Date : 6/23/2021 4:10:00 PM
From : "Pete Eyre"
To : "Wes Pringle"
Subject : Fwd: Sunset+Wilcox Assessment Letter
Attachment : Updated_CEN20-49786_6450 Sunset Blvd_MU.pdf;image001.png;image002.png;image003.png;image004.png;

6450 West Sunset Boulevard
DOT Case No. CEN20-49786

Subject: **TRANSPORTATION ANALYSIS FOR THE PROPOSED MIXED-USE PROJECT LOCATED AT 6450 WEST SUNSET BOULEVARD (CPC-2020-1929-HD-VCU-MCUP-SPR-RDP-WDI/ENV-2020-1930-EIR)**

Figure 1
Wilcox Avenue Two-Way Left Turn Lane Concept - North
Sunset+Wilcox

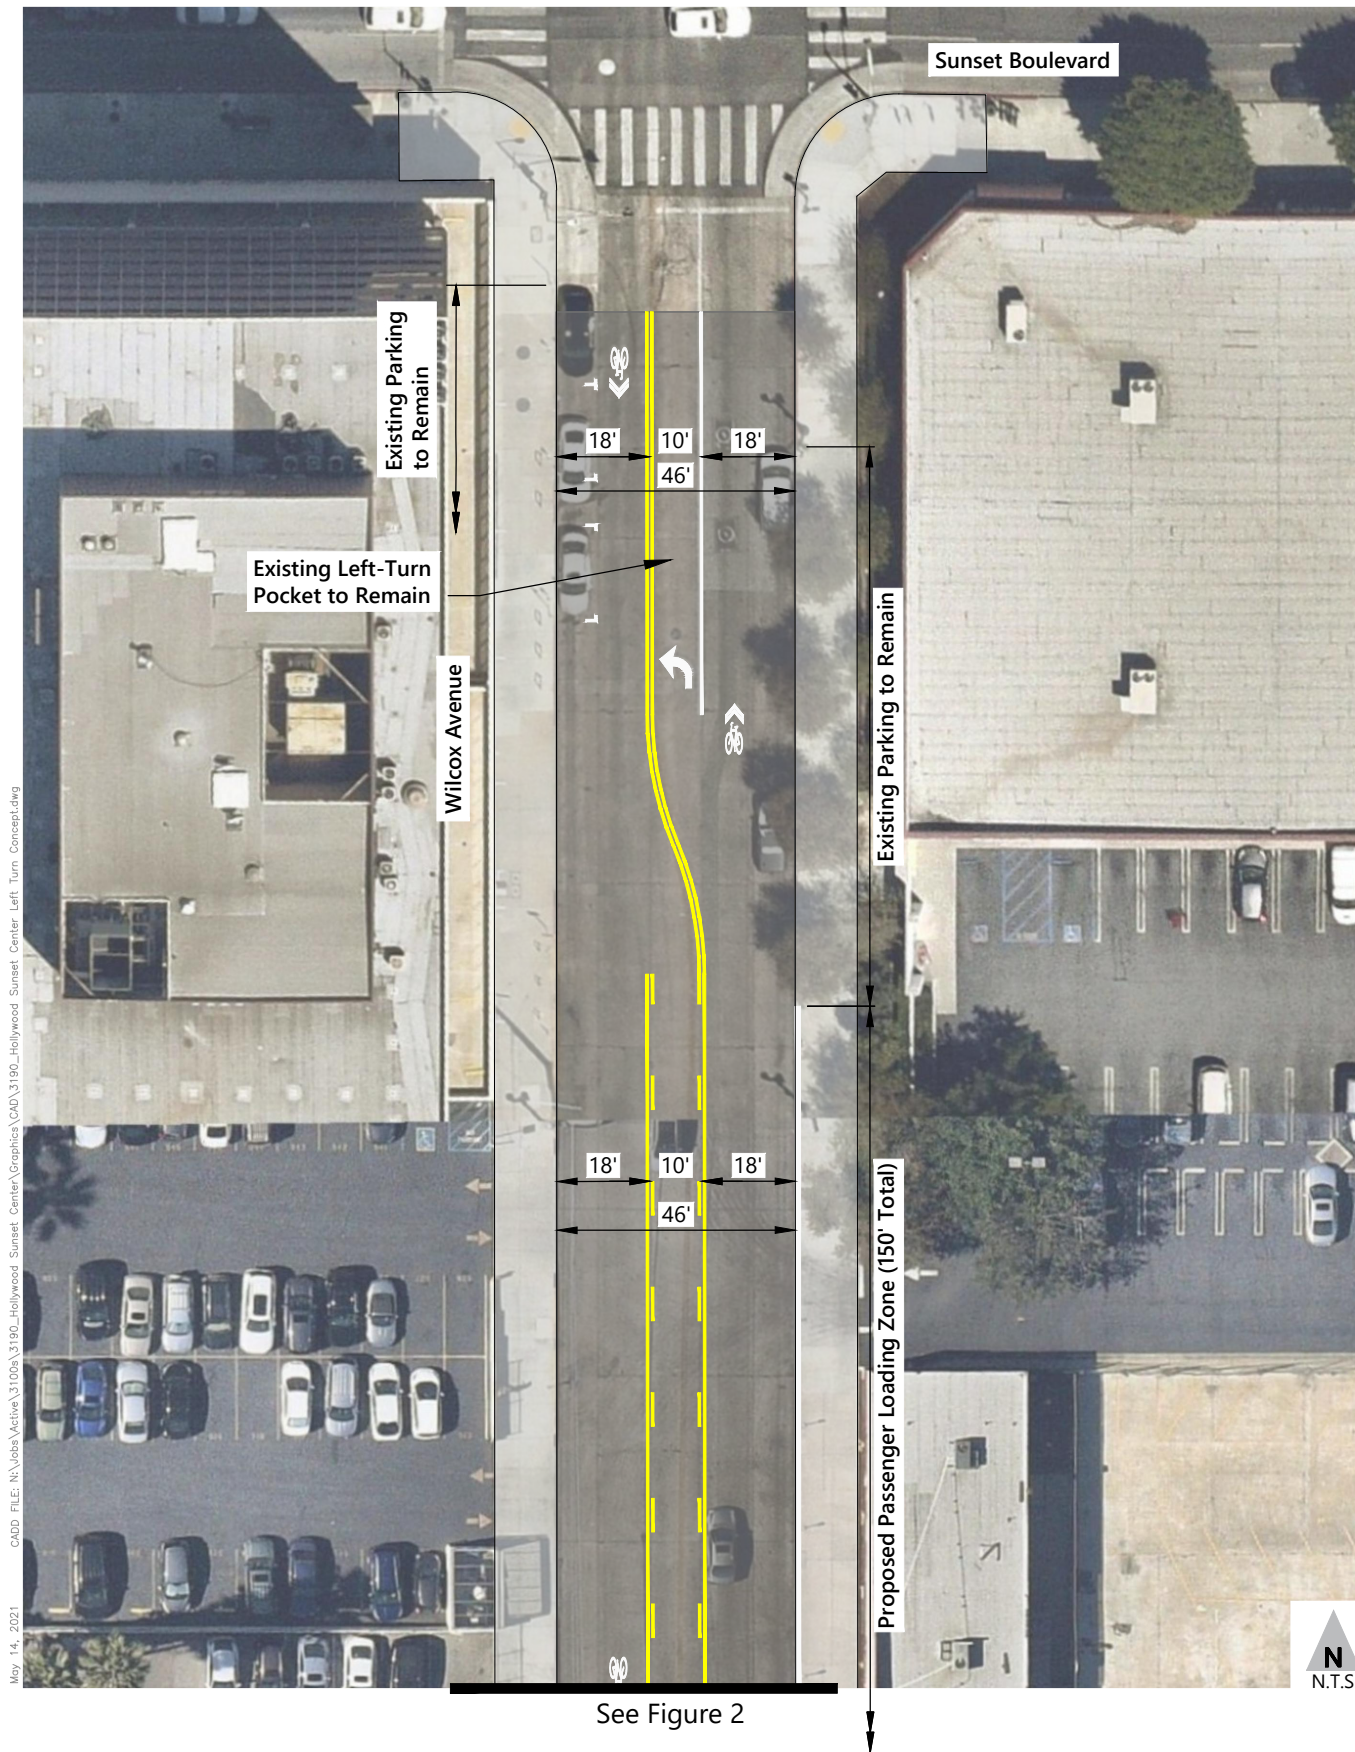
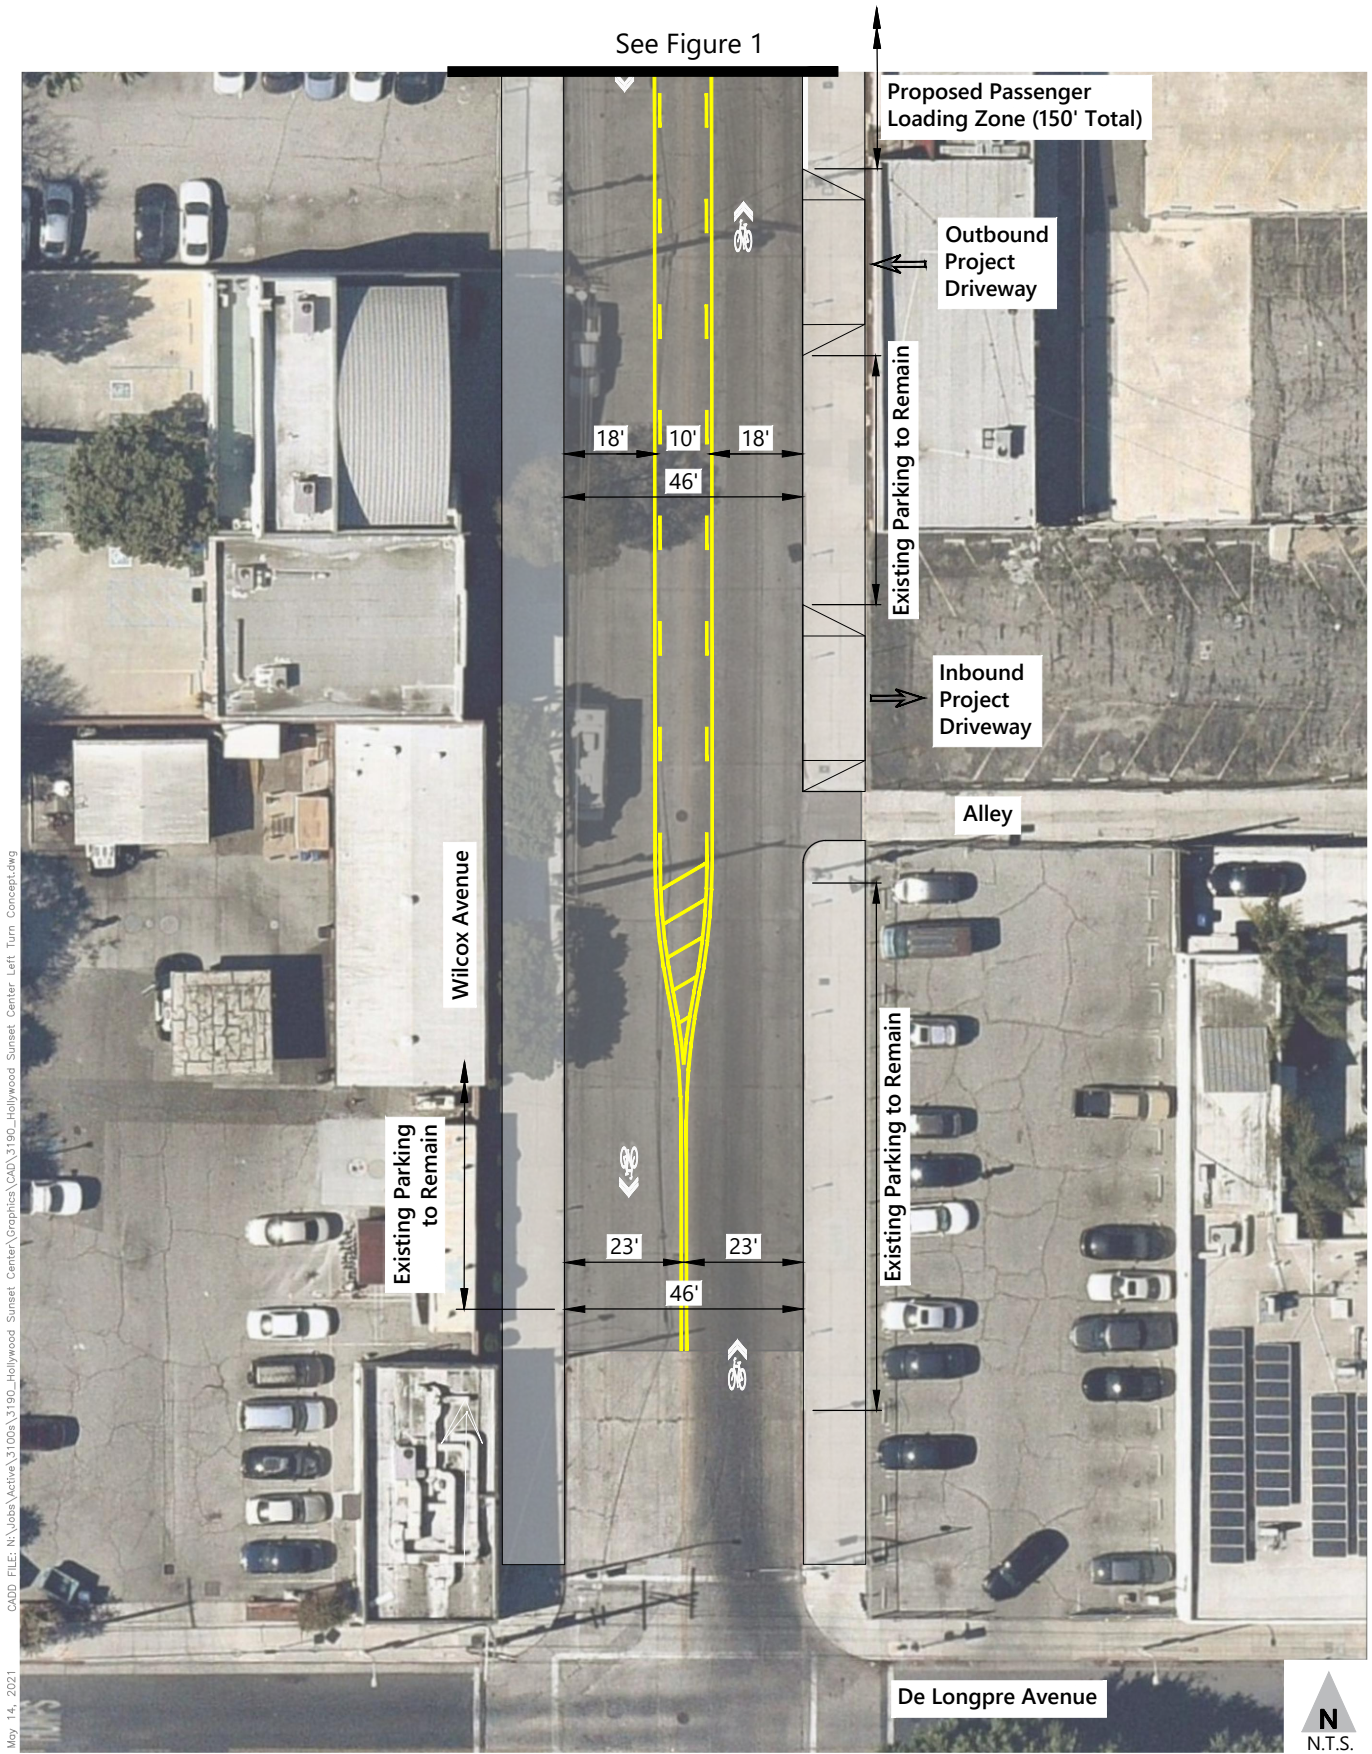
1. Restriping Wilcox Avenue: to provide a center left-turn lane for both directions of travel along Wilcox Avenue. This provides a space for southbound vehicles turning left from Wilcox into the project site to queue without blocking through traffic on Wilcox. Due to existing driveways along Wilcox, a turning lane for both directions is proposed rather than an exclusive pocket turn lane for southbound traffic only. See **Attachment D** for a conceptual design of this proposal.

This proposed corrective measure is subject to review by the LADOT Hollywood-Wilshire District Operations Office, which will also require coordination with the Geometric Design Group.
